May 21, 2014

Re: Expanding Access to Broadband and Encouraging Innovation through Establishment of an Air-Ground Mobile Broadband Secondary Service for Passengers Aboard Aircraft in the 14.0-14.5 GHz Band; GN Docket No. 13-114, RM-11640

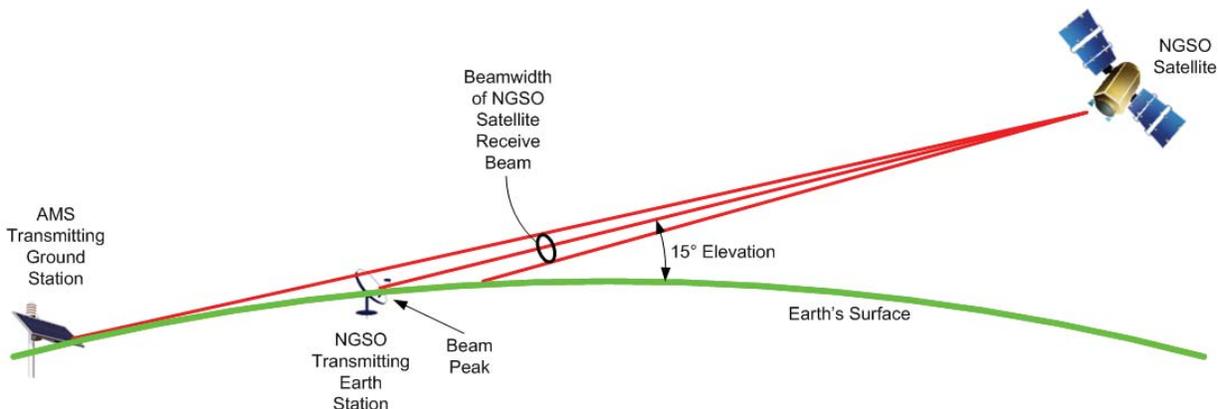
SIA also does not agree that an aggregate $\Delta T/T$ limit for the protection of NGSO systems is sufficient. As in the case of the GSO FSS, an aggregate limit with no prescribed method of compliance will be difficult to enforce and will not provide adequate assurance of protection for NGSO systems. Instead, SIA suggests that the Commission adopt a more robust mechanism for preventing interference to future NGSO systems, such as an EIRP density vs. elevation angle mask.²⁰ Contrary to Qualcomm's assertion, interference from AMS ground stations and aircraft terminals transmitting at low elevation angles will not be unusual. In fact, two known NGSO systems (outside the Ku-band) already operate with minimum elevation angles of 8 and 10 degrees, so the possibility that future NGSO systems may operate at low angles is high.²¹ Moreover, even NGSO systems nominally operating at slightly higher elevation angles (*e.g.*, 15 degrees) can receive interference from an AMS ground station or aircraft

station operating at lower elevation angles, as illustrated by the following diagram.²²
